Re: Variance Application: Katz Property (2023-0153-V)  
343 Kingsberry Drive, Annapolis Maryland 21409 (the "Property")  
Tax Map 46, Grid 3, Parcel 384, Lot 19  
Explanation Letter

G02019	
VARIANCE SITE PLAN	
KATZ PROPERTY ST MARGARET'S FARM SUBDIVISION SINGLE FAMILY DWELLING VARIANCE PLAN LOT 19, 343 KINGSBERRY DRIVE ANNAPOLIS, MD 21409	
TAX MAP: 46 GRID: 3 PARCELS: 384 THIRD ASSESSMENT DISTRICT SCALE: AS SHOWN	TAX ACCOUNT: 03-737-07969691 ZONING: RDL/OS ANN ARUNDEL COUNTY, MARYLAND 21409 DATE: MAY 2024 SHEET: 1 OF 1

## OFFICE OF PLANNING AND ZONING

SITE PLAN  
SCALE: 1"=20'

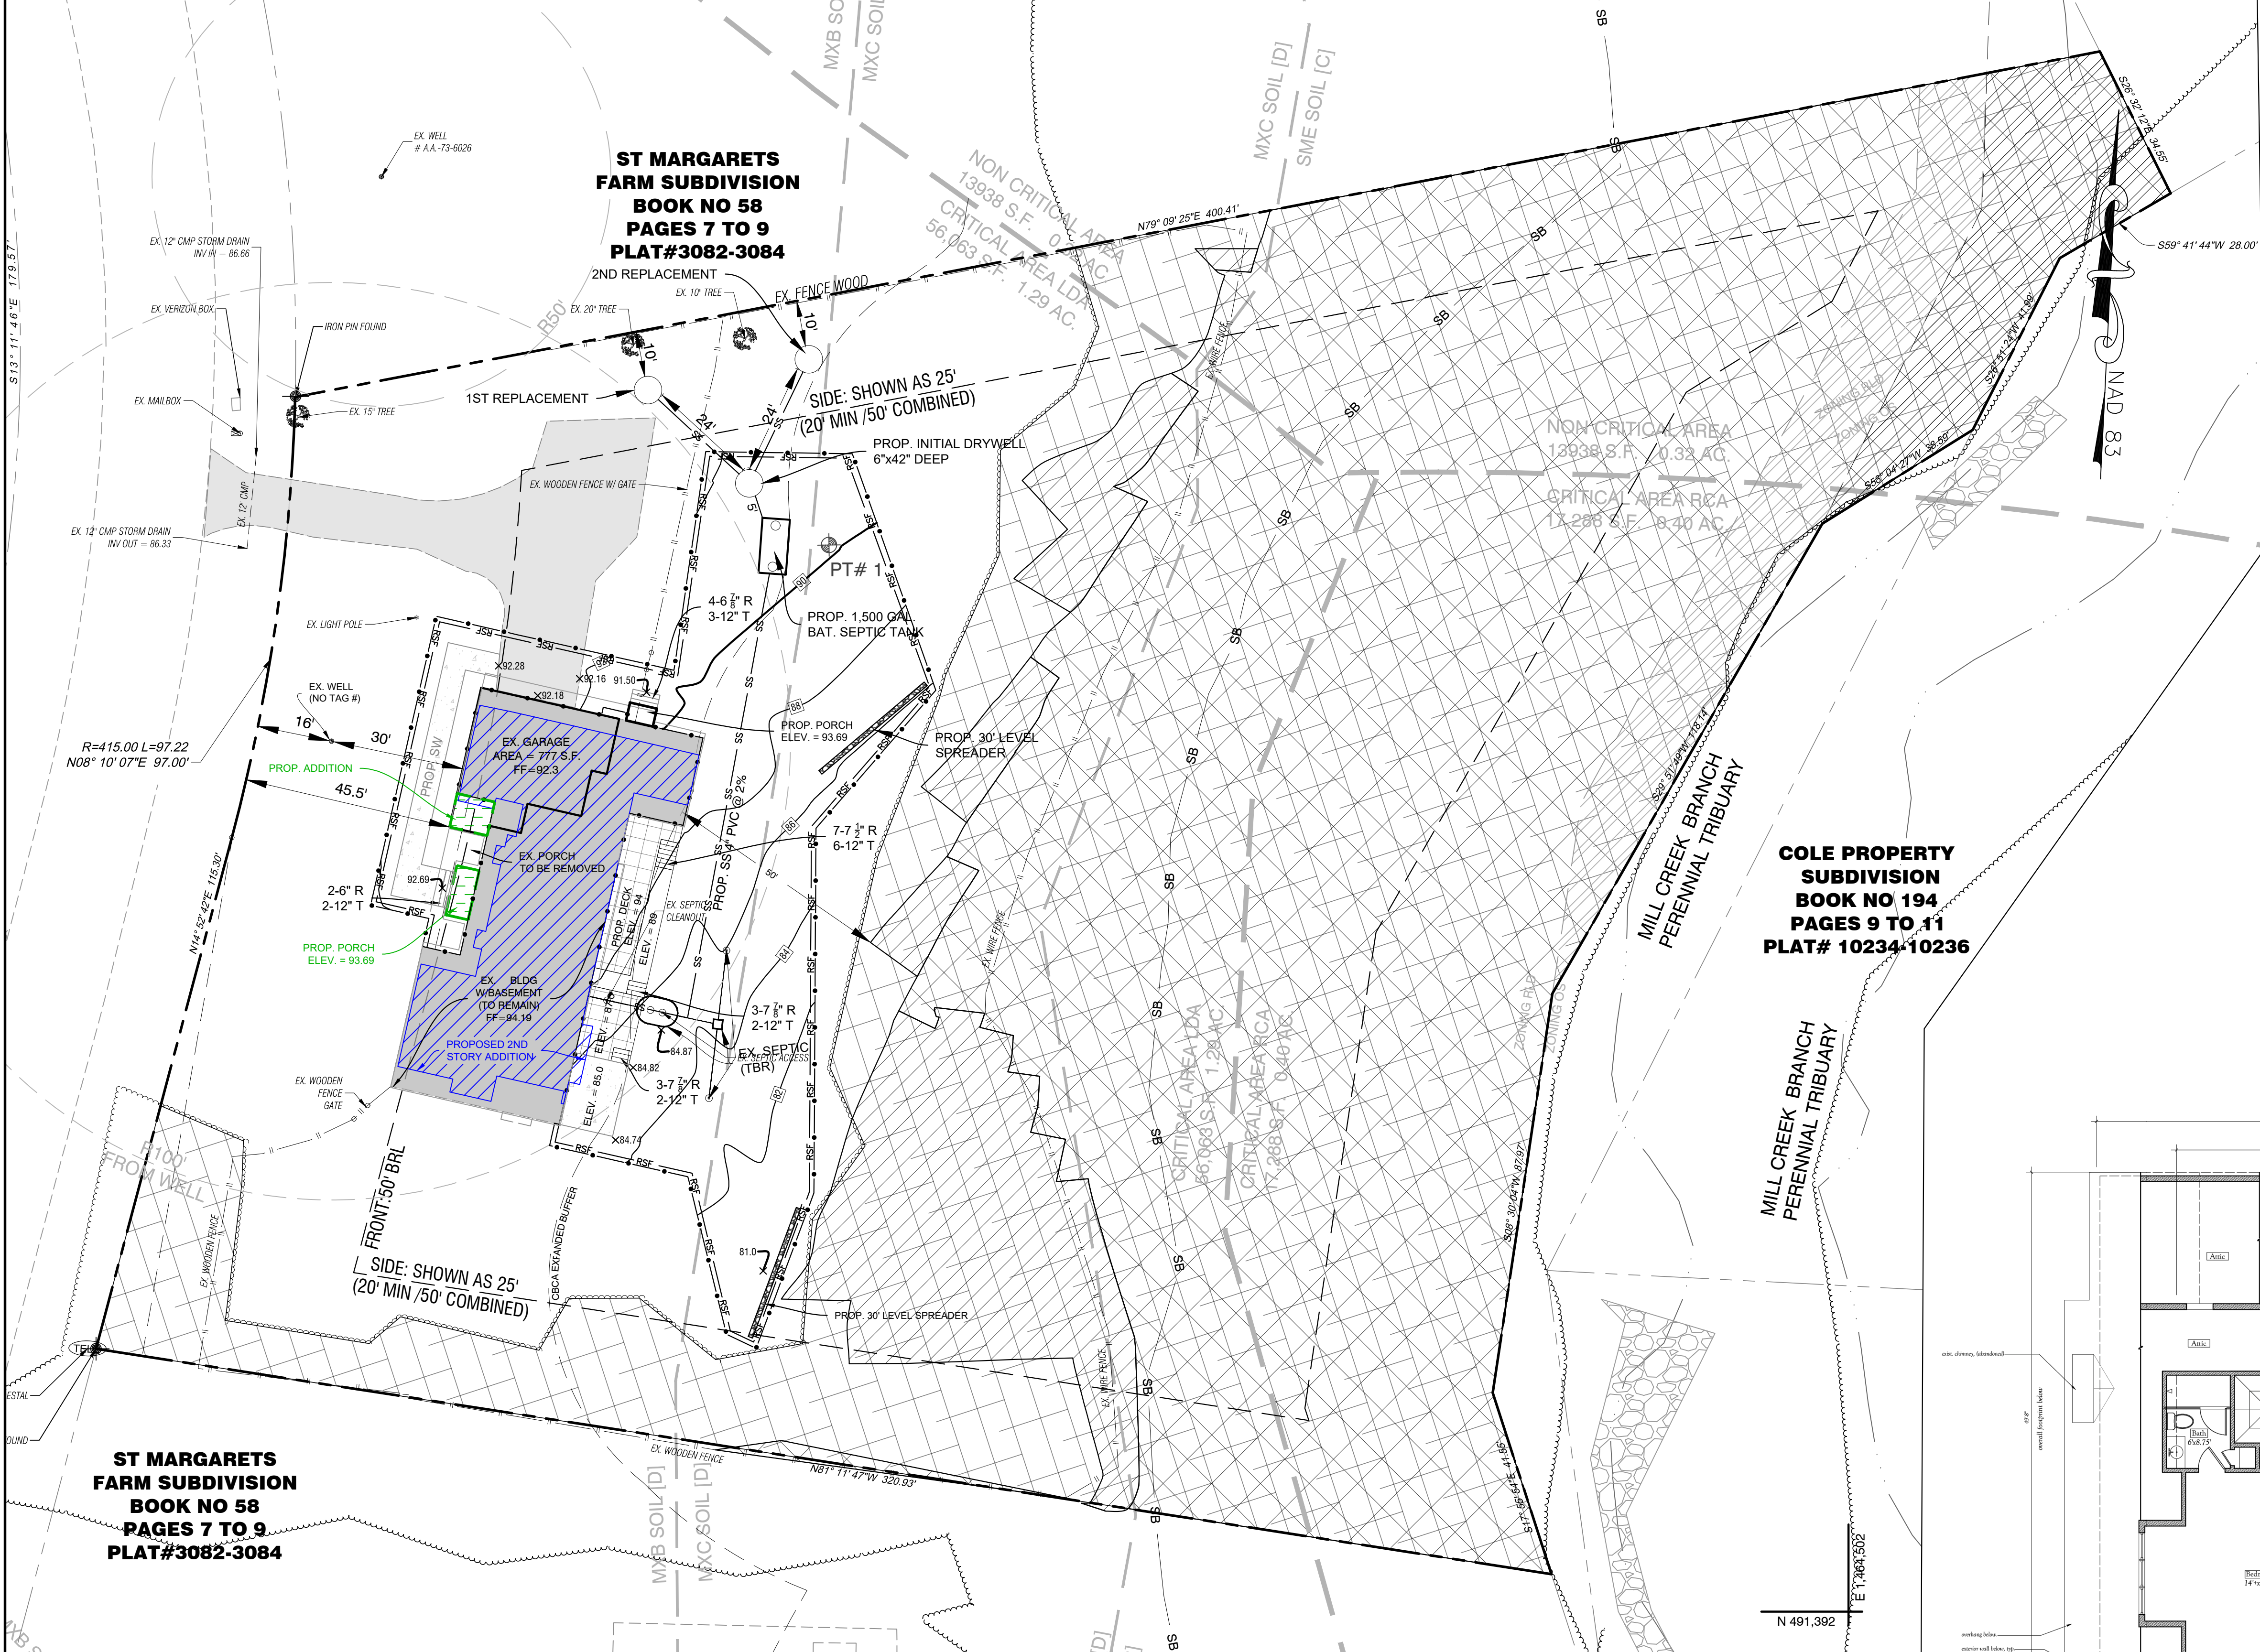
The **Zoning Administration Section** notes that the variance site plan must label the dimensions, height, and number of stories of the proposed structures. While the second story over the existing dwelling is reasonable, the applicant must demonstrate that the long deck meets all of the Critical Area variance standards and that the request is the minimum necessary to afford relief.

2. Please review existing vegetation (or lack thereof) within the steep slopes; opportunities to supplement vegetation or replanting buffers with native vegetation should be reviewed and provided to enhance water quality.

3. Show and label clearly the proposed SWM practice (s) on the site plan.  
4. A soil boring is required per practice. The suitability, and siting of proposed SWM practices should be reviewed. Soil boring information including verification of the suitability of in-situ soils for infiltration shall be submitted.
